project. Sherwood Library Renovation | 1225 Wonderland Rd N, London, ON

project no. 23-006

This Addendum is issued before the award of Contract to inform the Contractor of certain modifications to the work described in the Drawings and Specifications dated September 18, 2024.

end of addendum | 002

F0 FURRING WALL NO METAL STUD NON FIRE RATED
SCALE: 1"=1'-0"

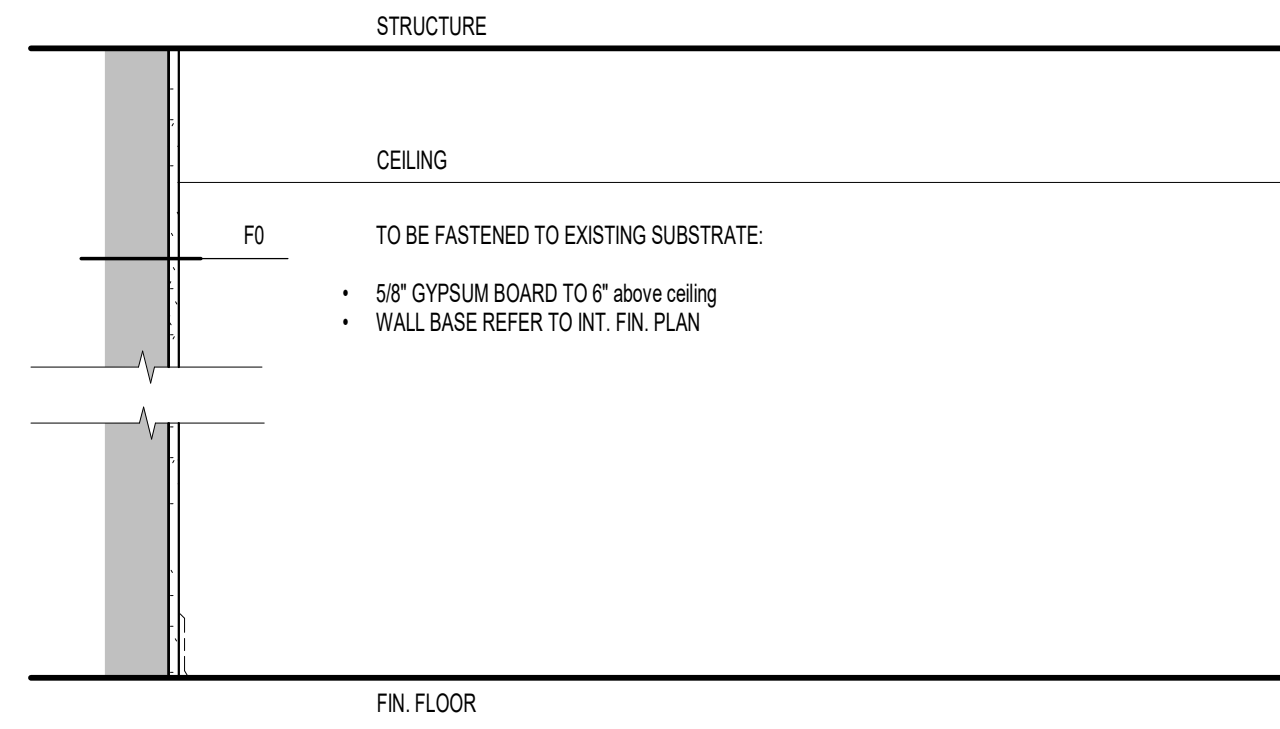
WALL ASSEMBLY QUESTIONS:	
1.5	<p>Question: Please confirm wall assembly type F0 along gridline 1.</p> <p>RESPONSE: F0 assembly is 5/8” gypsum board to 6” above ceiling.</p>

P3F1 PARTITION WALL 3 5/8" METAL STUD FIRE RATED (1 HOUR)
SCALE: 1"=1'-0"

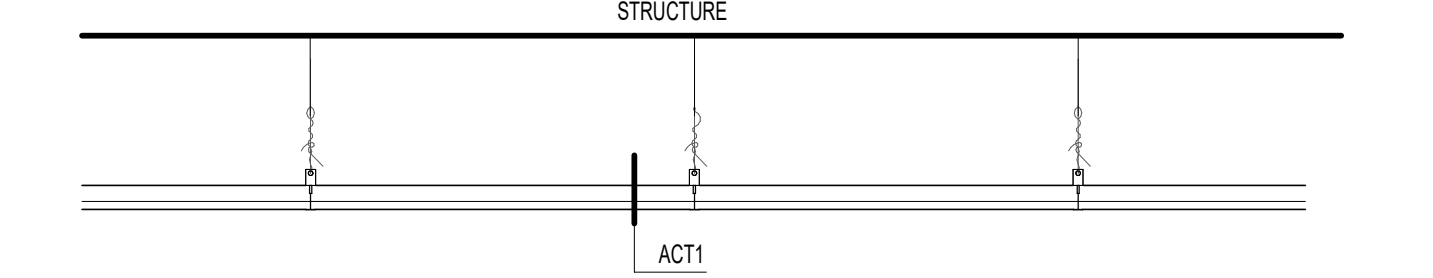
1.6	<p>Question: Please confirm that slotted deflection track is only required at assembly type P3F1. All other types, do not have drywall full height:</p> <p>RESPONSE: The GC shall confirm the deflection track requirements with the metal stud manufacturer, ensuring compliance based on the specified height and the construction assemblies provided.</p>

BH4 BULKHEAD 4 ARMSTRONG ACOUSTIBUILT CEILING SYSTEM
SCALE: 1"=1'-0"

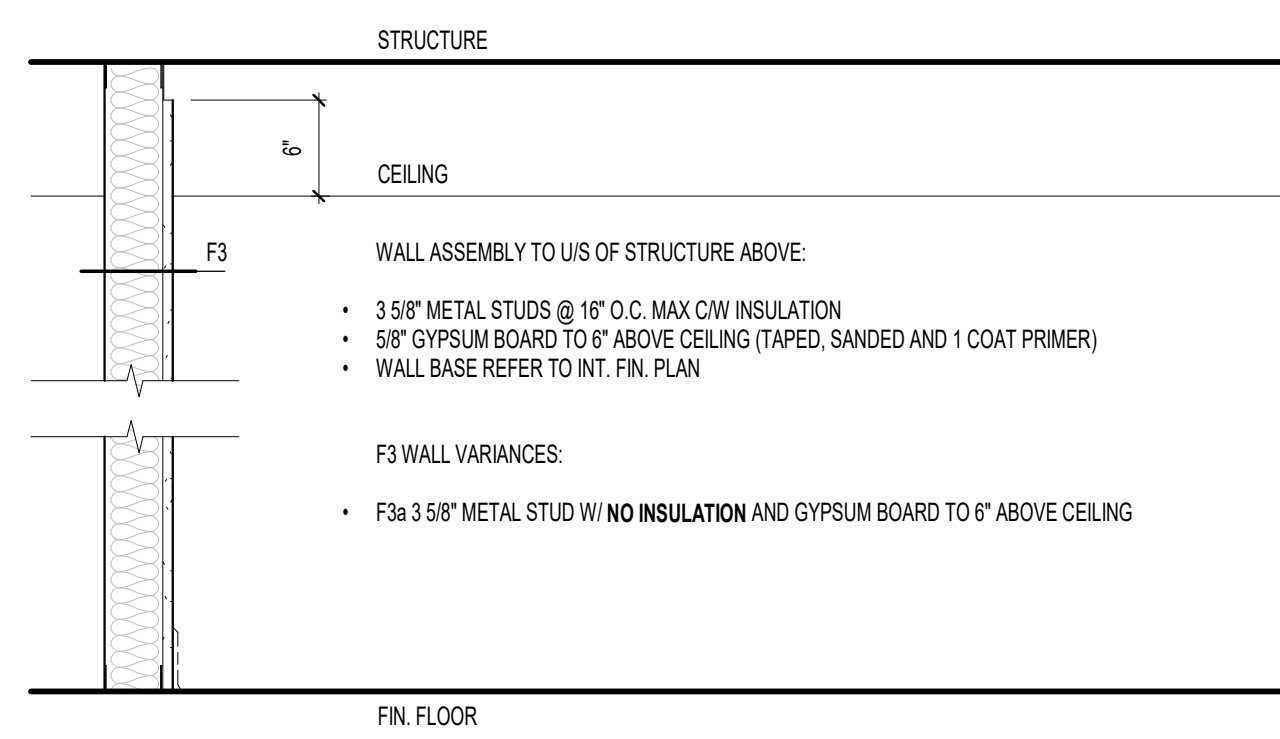
1.11	<p>Question: Is BH4/WG1 ceiling framing required to be engineered?</p> <p>RESPONSE: See installation instructions for complete requirements and performance standards outlined for the specified product.</p>

BH2 BULKHEAD 3 5/8" METAL STUD
SCALE: 1"=1'-0"

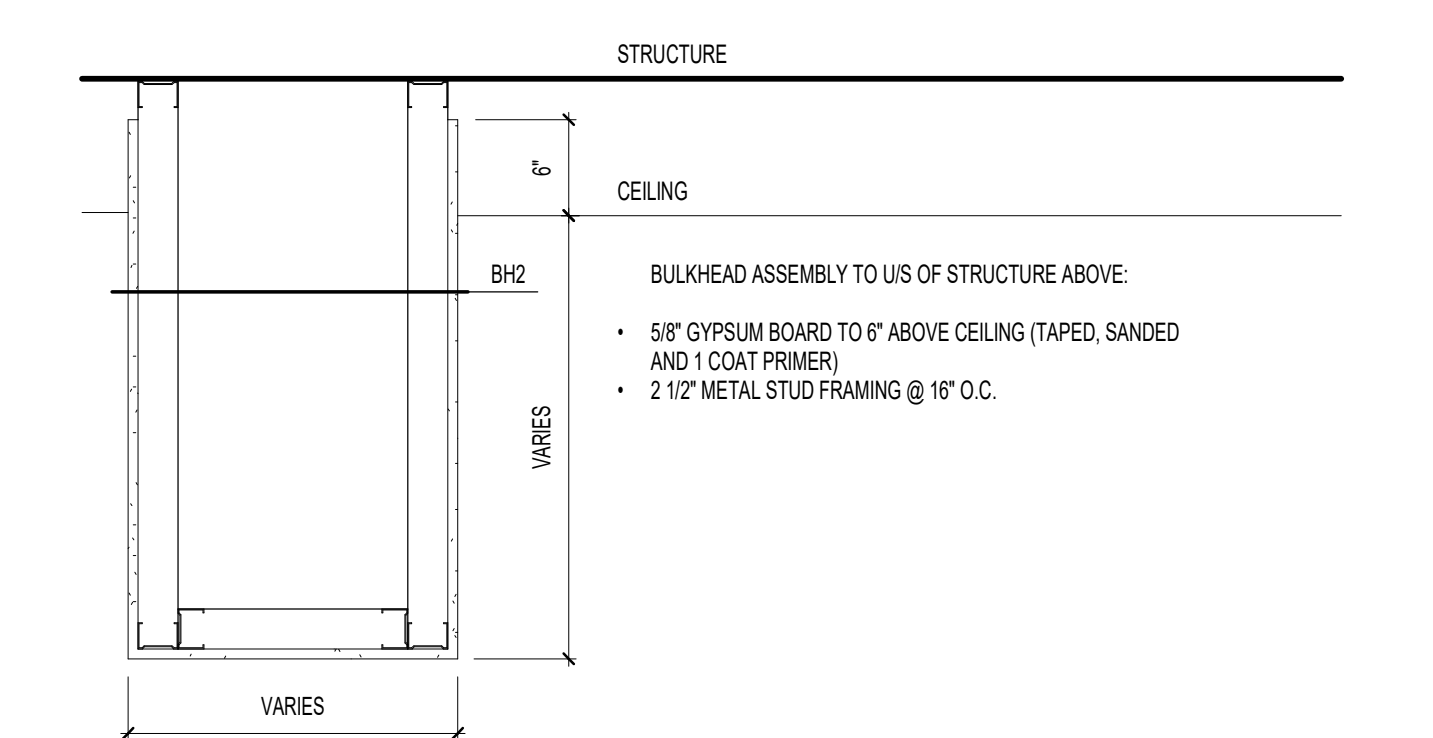
1.7	<p>Question: Please confirm that wall assembly types F1, F2, P3a are not used in the drawings.</p> <p>RESPONSE: F1 and P3a are not required and shall be removed. Use 2-1/2" metal studs for BH2.</p>

A1 RECEPTION DESK MILLWORK SECTION
ICC-203 Scale: 1" = 1'-0"

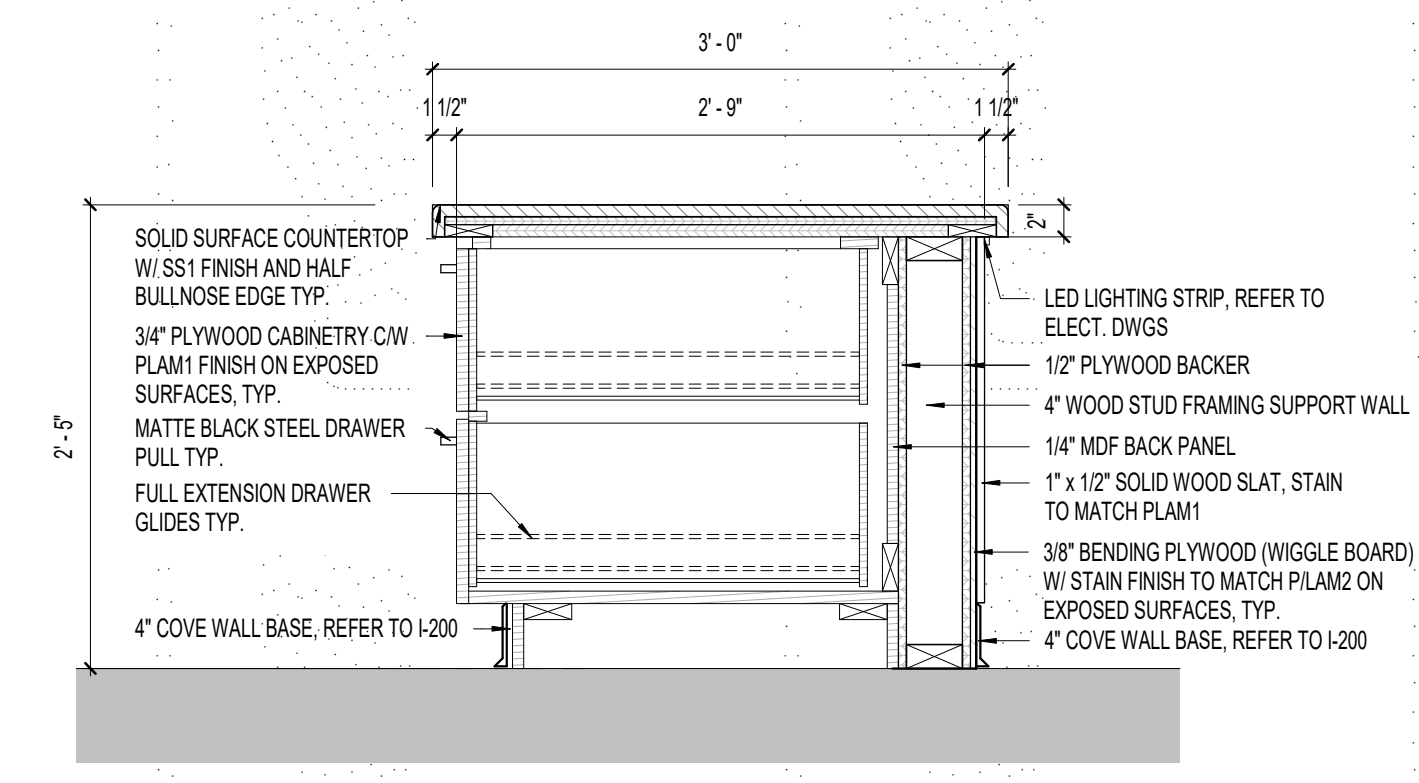
<p>2</p>	<p>Architectural Drawings Addendum #2 dated 2024.10.10 (3 pages) have regard to revisions and/or clarification to the following drawings</p>
<p>2.1</p>	<p>AG102 – ASSEMBLY TYPES</p> <p>Remove F1 wall assembly.</p> <p>Remove P3a from P3 wall variances.</p> <p>Remove BH1 ceiling assembly.</p>
<p>2.2</p>	<p>A221 - ENLARGED REFLECTED CEILING PLAN - NORTH</p> <p>Add recessed linear light fixtures to reception desk bulkhead as follows:</p> 
<p>2.3</p>	<p>ICC-203 MILLWORK PLANS, ELEVATIONS & SECTION DETAILS</p> <p>Add full length removable access panel to the reception desk on A1/ICC-203 as follows:</p>

DRAWN BY: U.E.
 PROJ. MGR/ARCH: M.D./W.A.
 CHECKED BY: M.D./W.A.
 APPROVED FOR CONSTRUCTION DATE:
 PLOT DATE/TIME: 2024-10-10 1:30:04 PM
 PROJECT NO: P-BIMSR-22-51
 REVISION NO: J
 SHEET NO: E100

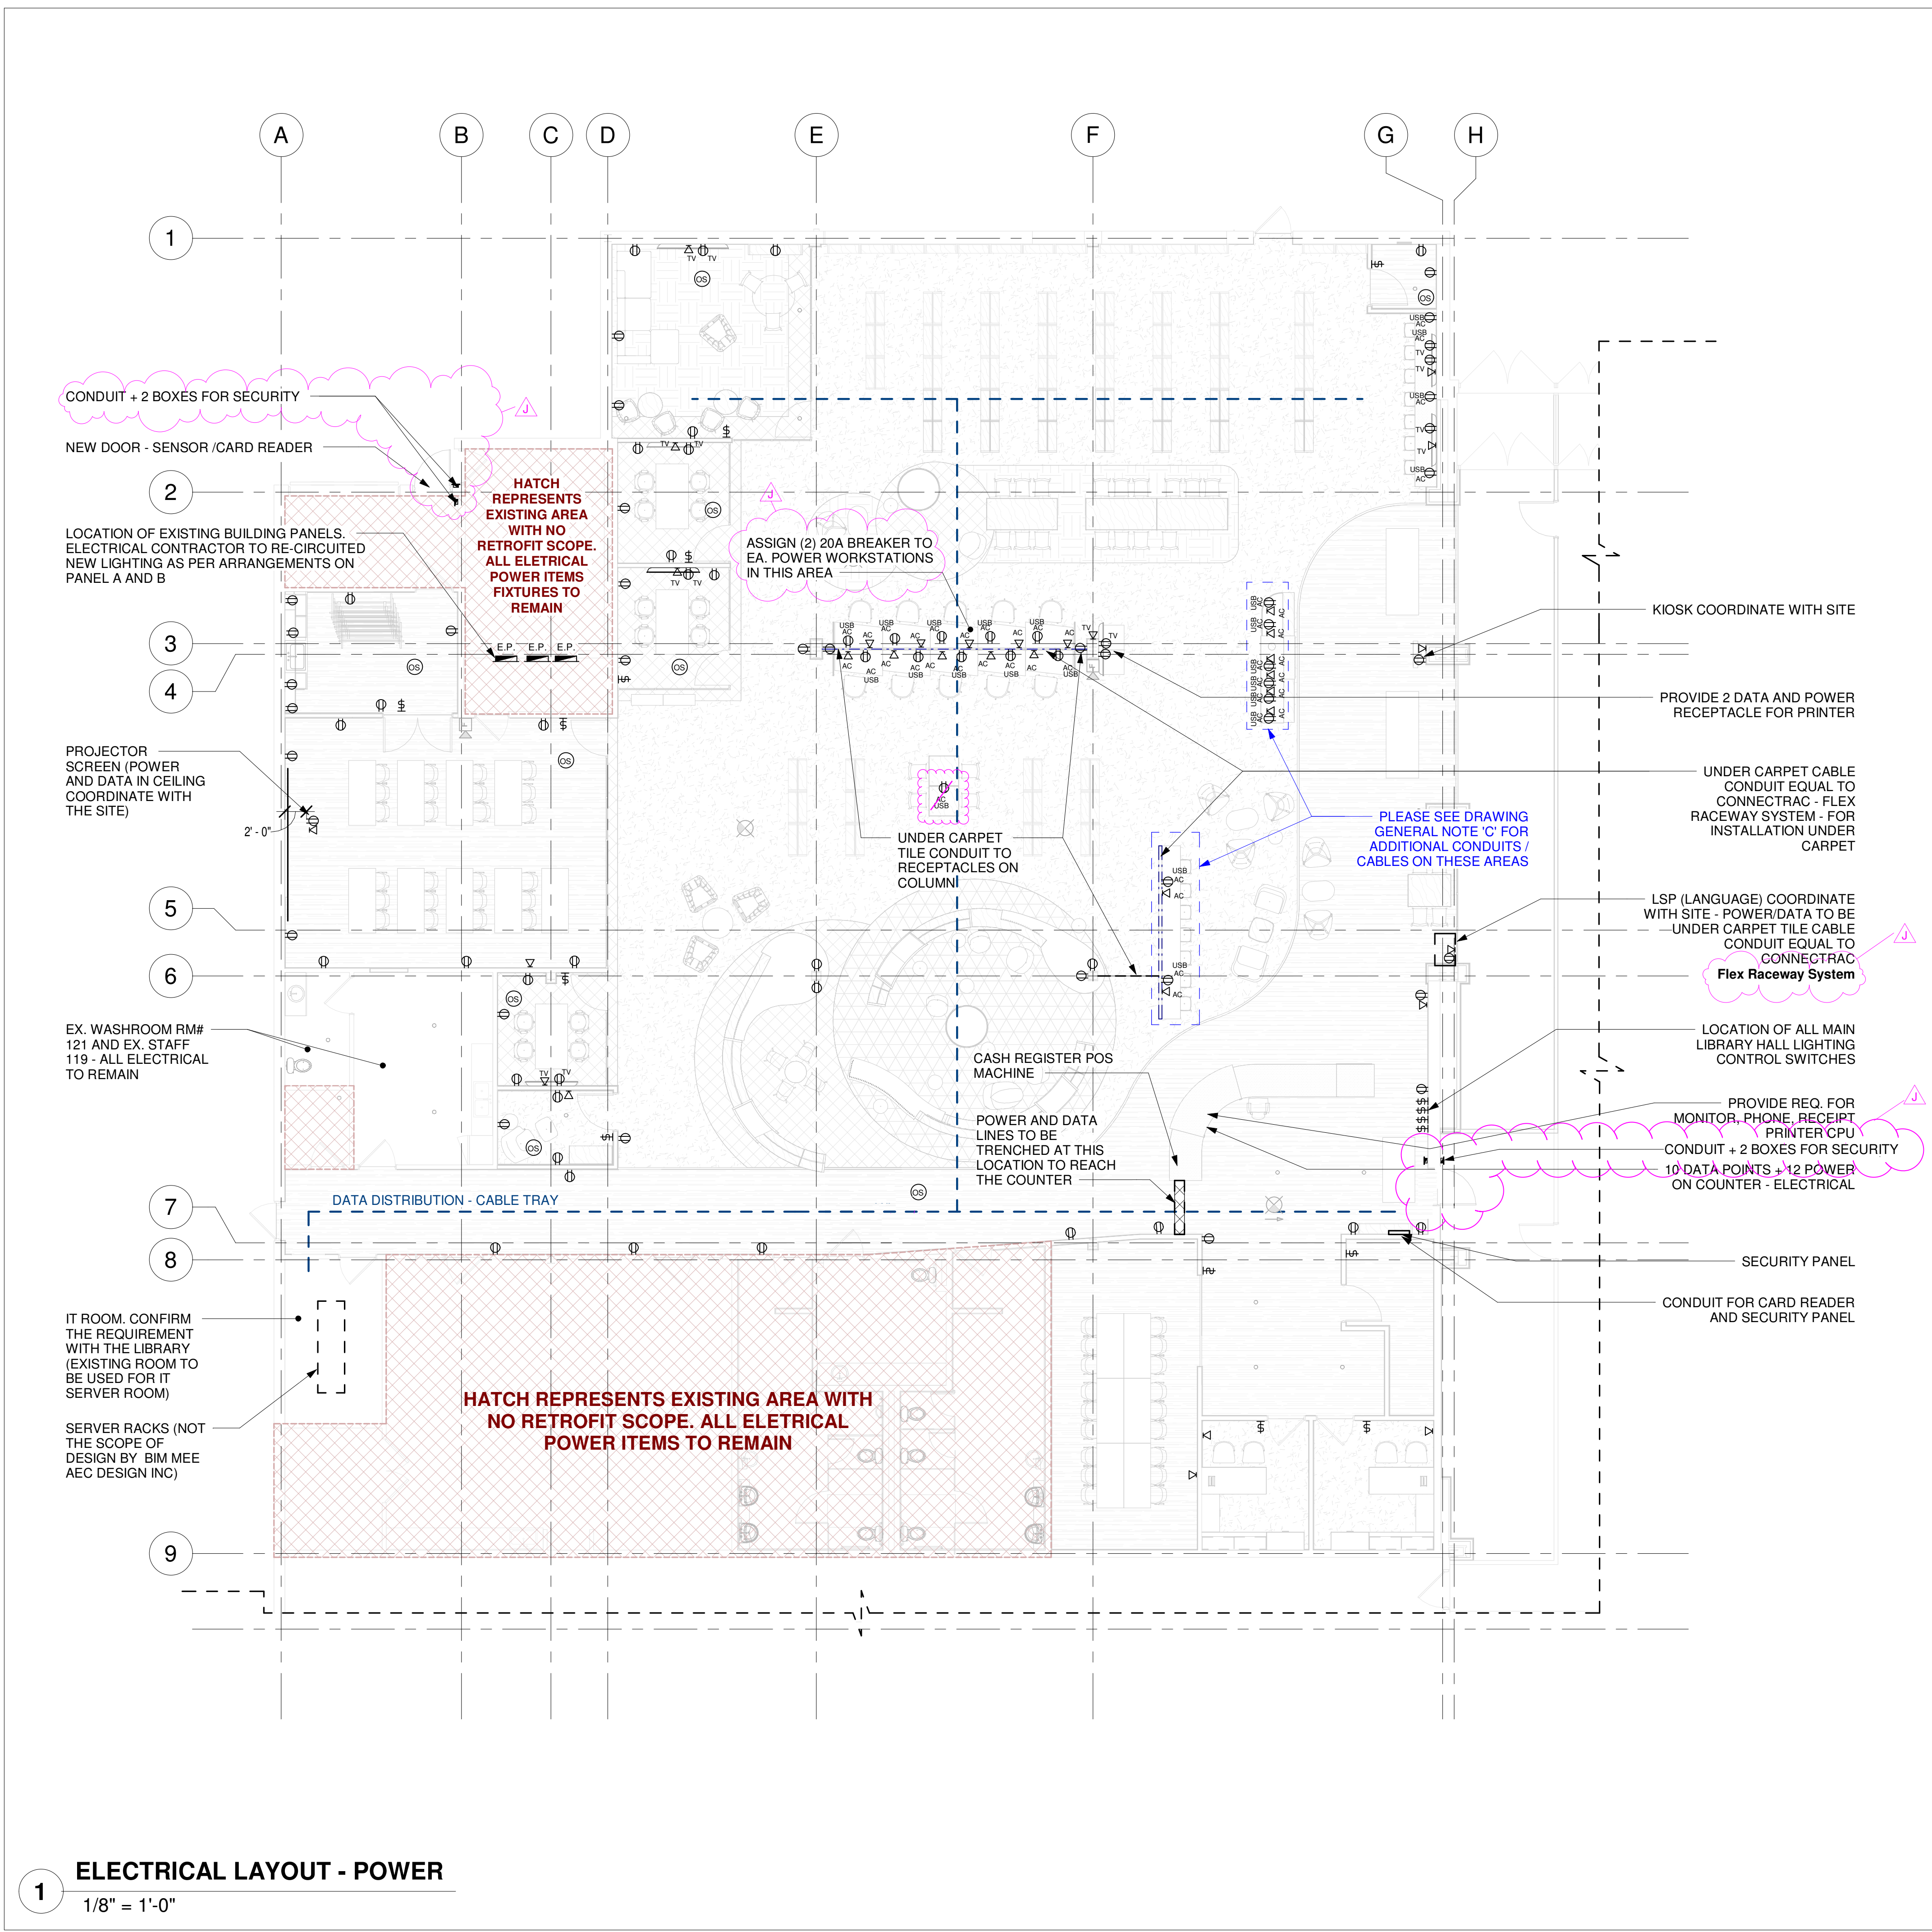
1.15	<p>Question: Lighting note 4, on E100 mentions type “A” motion sensor. Is that note referring to any lighting affected by motion sensors. Or Type “A” lighting fixtures controlled by motion sensors or a dimmer? Please clarify.</p> <p>RESPONSE: Occupancy Sensors are suggested for any isolated area including offices, rooms, meeting rooms etc. to enhance the building's energy efficiency – The main library hall can be controlled by switches by staff as indicated based on the library working hours.</p>

<p>1.27</p>	<p>Question: Please confirm the following details from the luminaire schedule on drawing E100 for Type A&B: Please confirm the product width (2.25", 3.18", or 4.5")</p> <p>RESPONSE: 2.25"</p>
<p>1.28</p>	<p>Question: Please confirm the following details from the luminaire schedule on drawing E100 for Type A&B: Please confirm the lumen output (250lm/ft is minimum, 1200lm/ft is maximum, must be selected)</p> <p>RESPONSE: 900 lmn / ft fixtures</p>
<p>1.29</p>	<p>Question: Please confirm the following details from the luminaire schedule on drawing E100 for Type A&B: Please confirm the CCT required.</p> <p>RESPONSE: Please provide adjustable CCT lighting fixtures with a default set at 4000K</p>

<p>1.30</p>	<p>Question: Please confirm the following details from the luminaire schedule on drawing E100 for Type D: Please confirm the lumen output and CCT requirements.</p> <p>RESPONSE: 4000k</p>
<p>1.31</p>	<p>Question: Is there missing demolition drawings for the existing power and lighting that needs removed in the existing area? I don't see any demo scope on these electrical drawings.</p> <p>RESPONSE: BIM MEE REPLY - There is no Electrical Demolition Plan in place. The locations of all new switches and receptacles have been provided. The master electrician is responsible for rearranging the circuits during the demolition process.</p>
<p>1.32</p>	<p>Question: E100 Lighting Note 3 States: All lighting not on a motion sensor shall be interconnected to building security system though the use of a lighting contractor. When Building is armed, all lighting not on a motion sensor shall turn off. – The lighting drawing does not indicate where any lights are being switched from. Please confirm which lighting is being switched together and where the lighting is being switched from.</p> <p>RESPONSE: Please refer to revised LIGHTING NOTES on E100.</p> <div style="border: 2px dashed #e91e63; border-radius: 50%; padding: 20px; margin: 20px 0;"> <p><u>LIGHTING NOTES:</u></p> <ol style="list-style-type: none"> 1. CONNECT ALL EMERGENCY FIXTURES LINE SIDE OF LOCAL LIGHTING CIRCUIT. 2. CIRCUIT BREAKER HANDLE LOCK-OFF DEVICES SHALL BE PROVIDED FOR BREAKERS SERVING EXIT LIGHTING AND EMERGENCY LIGHTING CIRCUITS. 3. DIMMING WIRING NOT SHOWN. PROVIDE 0-10V WIRING BETWEEN ALL TYPE A OCCUPANCY SENSORS OR DIMMER SWITCHES AND CONTROLLED LIGHTING. 4. PROVIDE MANUFACTURER-APPROVED COMPATIBLE DIMMER SWITCHES WHERE INDICATED ON PLANS. THE DIMMER MUST BE COMPATIBLE WITH THE DRIVER AND LOADS AS SHOWN. 5. OCCUPANCY SENSORS SHALL BE LOCATED AT LEAST 6' FROM ALL DIFFUSER LOCATIONS. COORDINATE LOCATIONS WITH MECHANICAL. 6. PROVIDE SEPARATE NEUTRALS ON ALL DIMMERS. </div>

<p>1.33</p>	<p>Question: E100 Lighting Note 4 States: Dimming wiring not shown. Provide 0-10V dimming between all Type A motion sensor or dimmer switches and controlled lighting. – There is no Type A motion sensors or dimmer switches and controlled lighting shown anywhere on the drawings. Please confirm what lighting is being controlled by motion sensors, dimmer switches.</p> <p>RESPONSE: BIM MEE REPLY – Please review drawings for OS indicating Occupancy Sensors.</p>
<p>1.34</p>	<p>Question: Is there missing demolition drawings for the existing power and lighting that needs removed in the existing area? I don't see any demo scope on these electrical drawings. Is the data scope to be completed as part of this project or just the rough ins and the library will have their own data sub complete the work at a later date?</p> <p>RESPONSE: GC to install all required conduits and infrastructure for all security, data, pos, bas systems. Third party systems to be installed by others.</p>

<p>1.41</p>	<p>Question: Electrical print E100, under lighting note # 4. Provide dimming between all type A motion sensors or dimmer switches and controlled lights. I don't see any dimmers on the prints, don't see any dimming controllers. There is no designation on the ceiling mounted motion sensors, nothing states which ones are type A. Do these notes apply to this job. If so please give further info to clarify.</p> <p>RESPONSE: Please look for "OS" on E100 for Occupancy Sensors locations.</p>

<p>1.42</p>	<p>Question: Please advise if the following products will be considered as approved equals to the specified luminaires on drawing E100. Type A & B – 3G Lighting Linea https://3glighting.com/File/Product/460/3G-2RLI.pdf https://3glighting.com/File/Product/506/3G-4RLI.pdf - Note: Need confirmation on luminaire width, specified lumens per foot, and colour temperature as this is not detailed in the luminaire schedule.</p> <p>RESPONSE: No, upon review, these products are not consistent with the specified fixtures.</p>
<p>1.43</p>	<p>Question: Please advise if the following products will be considered as approved equals to the specified luminaires on drawing E100. Type C – Cooper Lighting HCSQ6 https://www.cooperlighting.com/api/assets/v1/file/CLS/content/halocommercial-hcsq6-spec/HALO-Commercial-HCSQ-6-inch-Square-spec-sheet.pdf</p> <p>RESPONSE: No, upon review, these products are not consistent with the specified fixture.</p>
